SOP53

2 FIG TREE DRIVE

RESPONSE TO GMU COMMENTS

AUSTRALIA AVE WALL

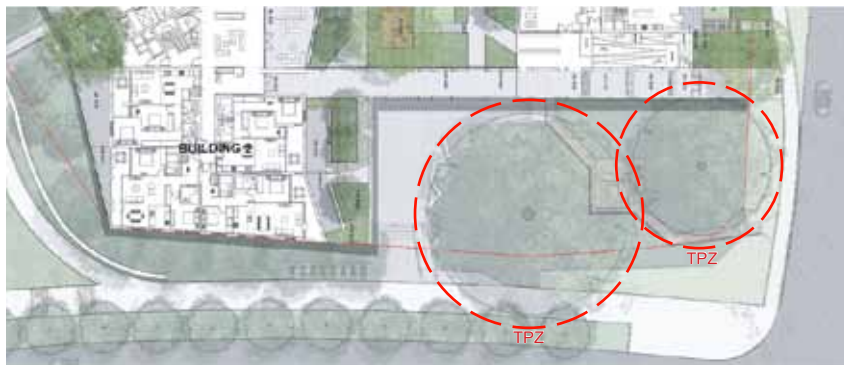
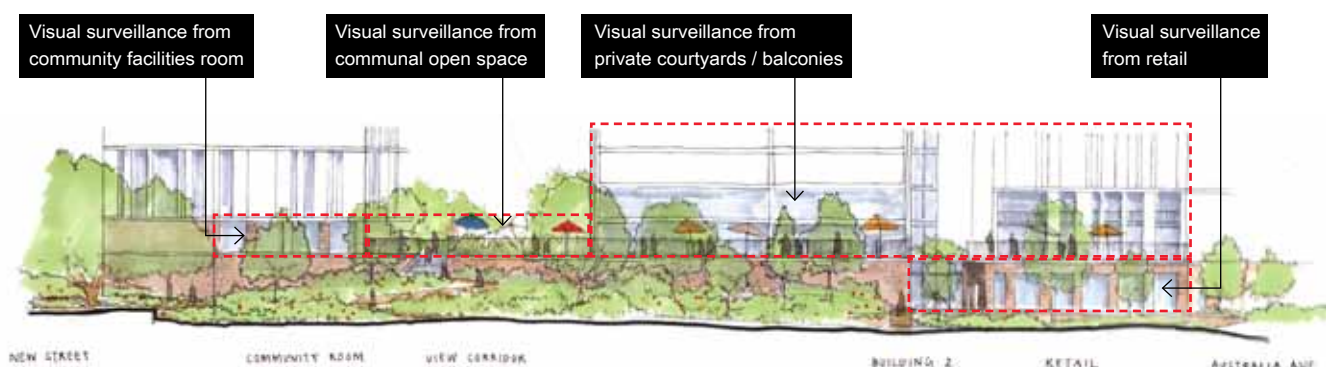
The north east wall of Building 1 fronting Australia Ave is required to be free of obstruction for multiple reasons.

- the low portion of this wall is louvred to provide necessary ventilation / exhaust for the basement carpark
- the landscape directly adjacent the wall falls within the tree protection zone (TPZ) of the 2 Fig Trees identified retention. The landscape levels in this area maintain existing levels to satisfy TPZ requirements, and can not be mounded.

It is also important to note that the visibility of the wall is highly screened and obscured from Australia Ave by the retention of the 2 large existing Fig Trees and will be supplemented by additional screening plants creating a tall dense screen which will conceal the wall and louvres. Refer to the below supporting images.

Sketch Elevation of Linear Park

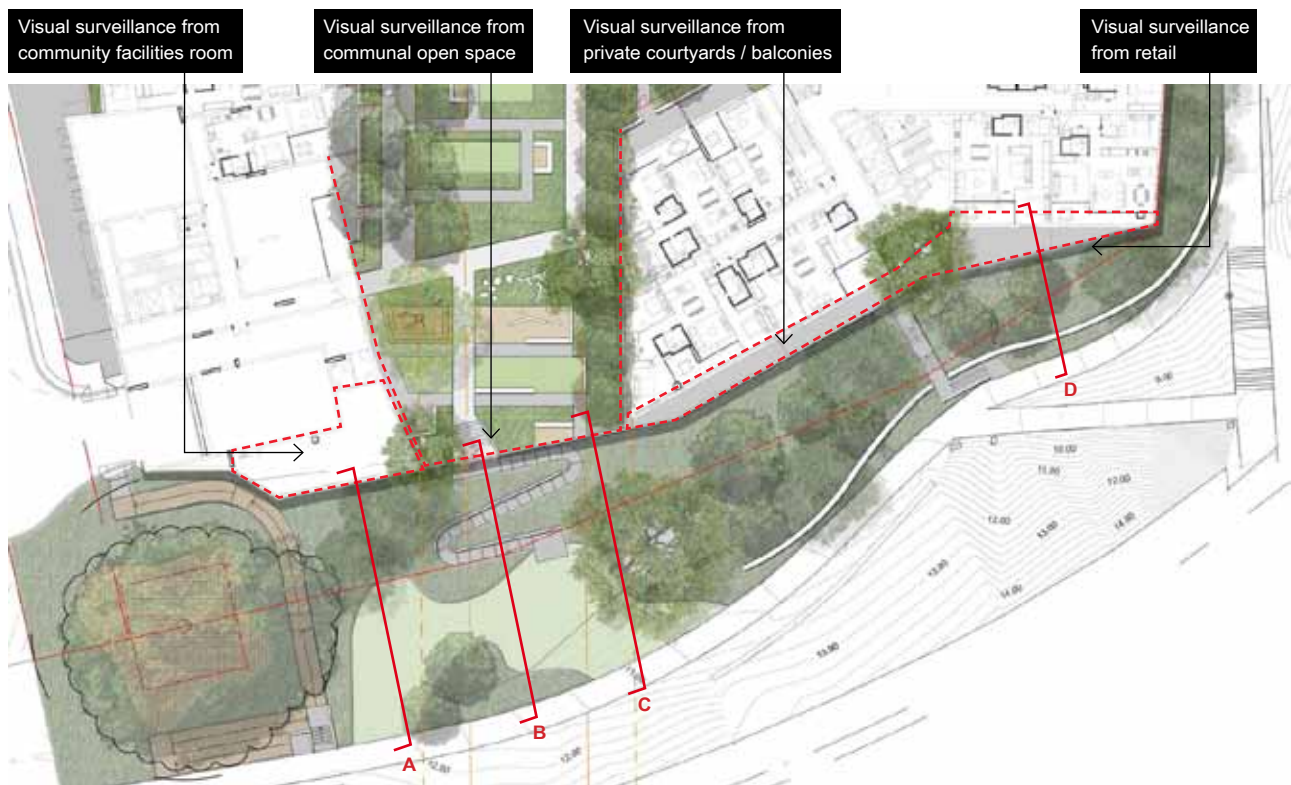
Due to the sloping nature of the site, level difference of 6.25m from the Northern Boundary along Fig Tree Drive to the southern boundary along Linear Park, the basement edge along linear park is visible. However, the landscape design along the linear park frontage has ensured that the extent of basement protruding is minimal (approx 1m), and that the plant species along the linear park frontage has been selected to achieve high dense screen which will conceal any walls from visibility. The elevation of the communal open space and private courtyard / balconies along the southern boundary not only achieves security and privacy from the public domain, but also encourages visual surveillance of the linear park from the development. Additionally, there is retail to the Australia Ave / Linear Park corner located on the Basement 01 level which is treated with a glass facade promoting visual connection and passive surveillance of the linear park. Refer to the supporting images below.
